Source: Rapporteur (SK Telecom)

Title: Answer to questions and comments on USTS

Document for: Discussion

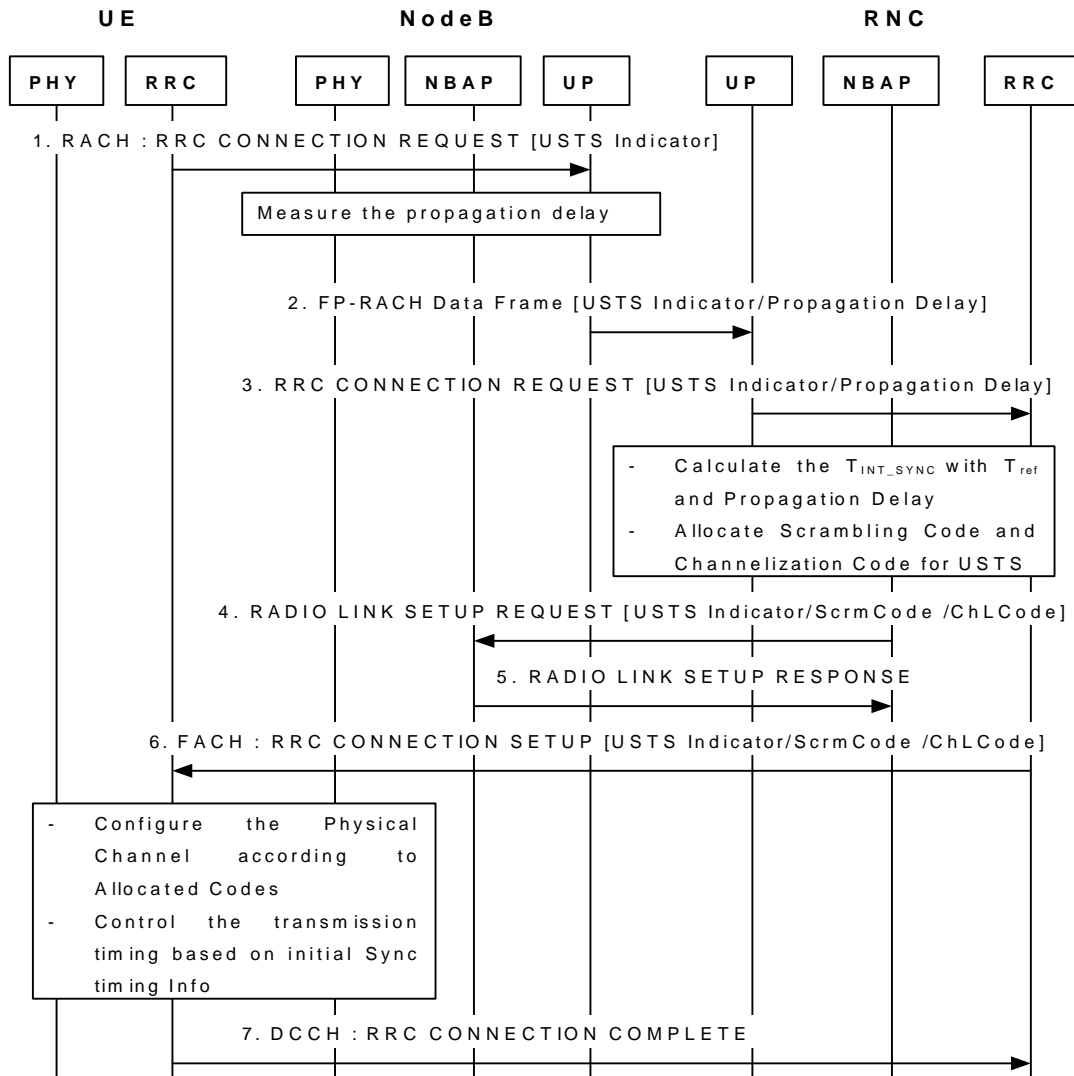
11) Performance gain when USTS and non-USTS mode UEs are mixed..

By using the analysis in section 2.2 in Tdoc904, when aN UEs are in USTS mode and $(1-a)N$ UEs are not in USTS mode, eqn. (2.8) can be modified to

$$\left(\frac{E_b}{I_o} \right)_i \approx \frac{GL}{N(L-a)}. \quad (1)$$

Hence, the gain is changed from $L/(L-1)$ to $L/(L-a)$. As more UEs are in USTS mode, more performance gain is expected. At an initial stage, a small number of UEs are in USTS mode. However, as time goes by and more UEs become to support USTS, then the performance gain increases.

Figure 1. An example for UE state.

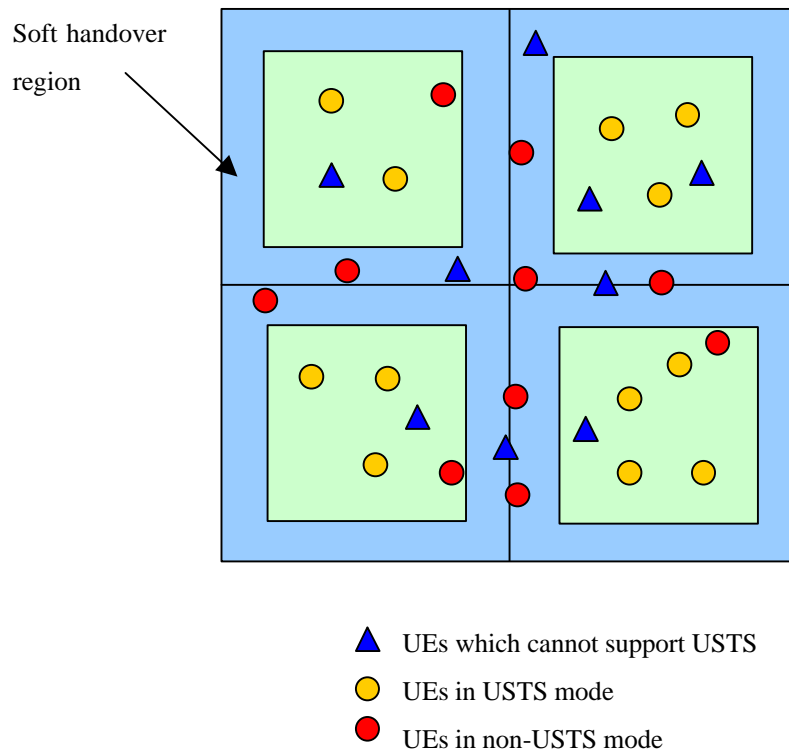
Appendix B: Procedure for soft handover (Candidate 1)

To support soft handover, the UE in USTS mode first changes its mode from USTS mode to non-USTS mode and then performs soft handover and if the UE no longer requires more than one links, it remains in non-USTS mode after deleting unnecessary link(s). By providing this kind of soft handover, both the intra-cell interference and inter-cell interference can be reduced owing to USTS and soft handover, respectively.

Figure 1 shows an example case for UE state. Let's assume that R99 UEs cannot support USTS and R00 UEs can support USTS and that R99 UEs coexist with R00 UEs. R00 UEs are in non-USTS mode when they are either in SHO or after SHO. Otherwise, they are in USTS mode.
